# BC BUILDING CODE INTERPRETATION COMMITTEE

**File No: 12-0066**

**INTERPRETATION**

| Subject:                    | Vertical transition of combustible to non-combustible DWV pipe |

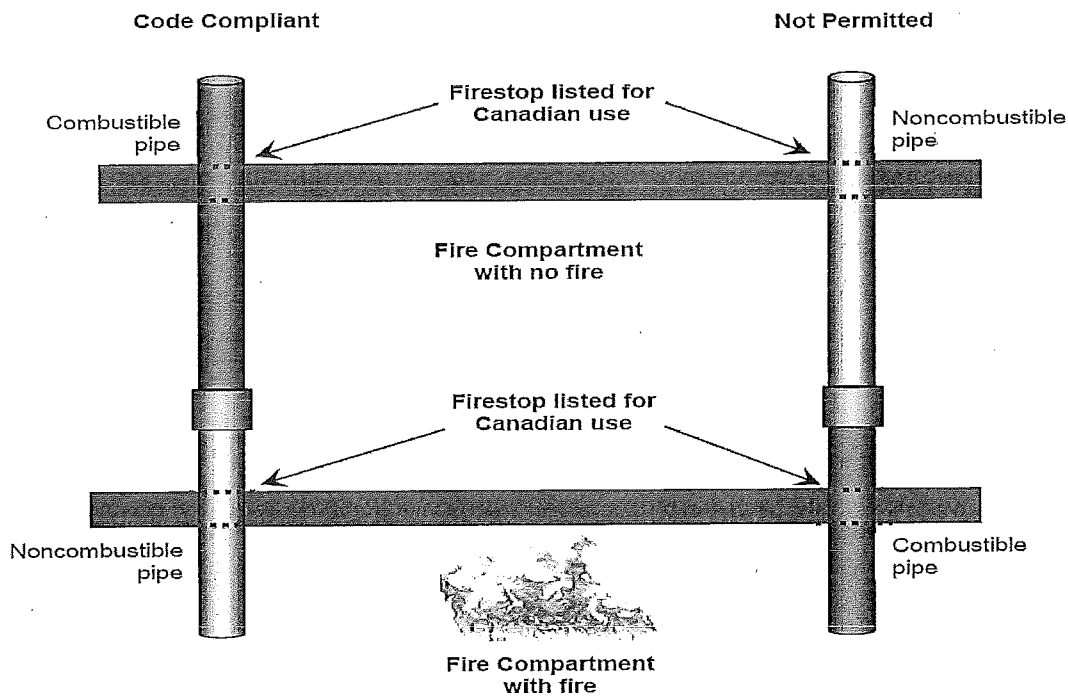
Can a vertical transition from combustible plastic drain, waste and vent (DWV) pipe (on the bottom) to non-combustible cast iron DWV pipe (on the top) take place above a fire-rated slab in a multi-storey building as long as a listed fire stop is used, such as cUL-F-B-2009, which includes the transition within the listed assembly?

The transition from combustible to non-combustible DWV pipe in cUL F-B-2009 was located above the floor slab in the unexposed side while the firestop system below the slab is in the fire exposed side. If the non-combustible pipe, after the transition, is extended through the floor above it makes the transition located on the fire exposed side if a fire occurs on the upper side of the floor slab where the transition takes place. During a fire condition above the slab the transition will fail leaving the non-combustible pipe open creating a chase through which flame and smoke can spread to the floor above (see attached illustration).

Clause 3.1.9.1.(1)(a) requires that the fire stop when subjected to the fire test method in CAN/ULC-S115 has the required fire-resistance rating. Since the transition has not been tested on the fire exposed side (within the test furnace) it would not be able to confirm if the fire stop has the required fire-resistance rating.

It is not acceptable for the transition from a combustible DWV pipe (on the bottom) to a non-combustible DWV pipe (on the top) to take place above the fire-rated slab if the non-combustible pipe

is further extended through multi-storey fire separations above the slab even though the combustible pipe is protected by a firestop, such as cUL F-B-2009, which includes the transition within the listing unless the transition has been tested on the fire exposed side.
